T.I. no.: 2021-15 Updated:	Topic: Product Optimisation Rear Cover
---	---

PRODUCT OPTIMISATION REAR COVER

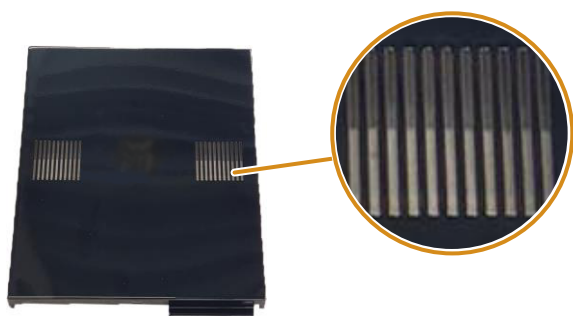
It has been found that under certain circumstances moisture may form in the machine interior due to condensation.

One reason for the formation of moisture is that when several beverages with a large volume (e.g. hot water 300 ml) are dispensed one after the other, the steam produced during this process is drawn into the machine interior via the ventilator and cannot be removed from the machine interior fast enough.

In order to improve the air conditioning in the machine interior, with this product optimisation the ventilation slots of the rear cover have now been changed.

4 ventilation slots have additionally been added and the width of the ventilation slots has been increased.

New – per field:

- 11 ventilation slots
- 2,8 mm width per slot
